Request for Information

RFI# M-0138

To:	Rob Piti & Kyrollos	From:	Apinder Singh
Fax:		Pages:	1(Including Cover)
Phone:		Date:	2025-05-13 12:30:19
Re:	McMaster University -Confirmation to HTS for Runtal Release		
□ Urgent ⋈ For Review □ Please Reply □ Attachment

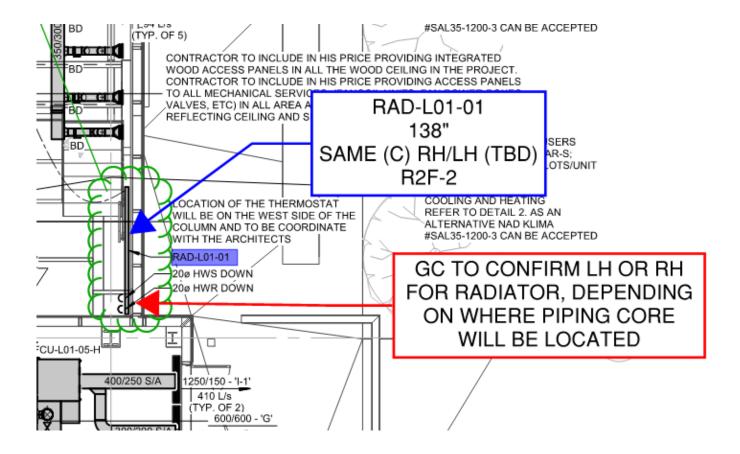
1. Confirmation to move lines to proposed location for Tags below for radiator connections.
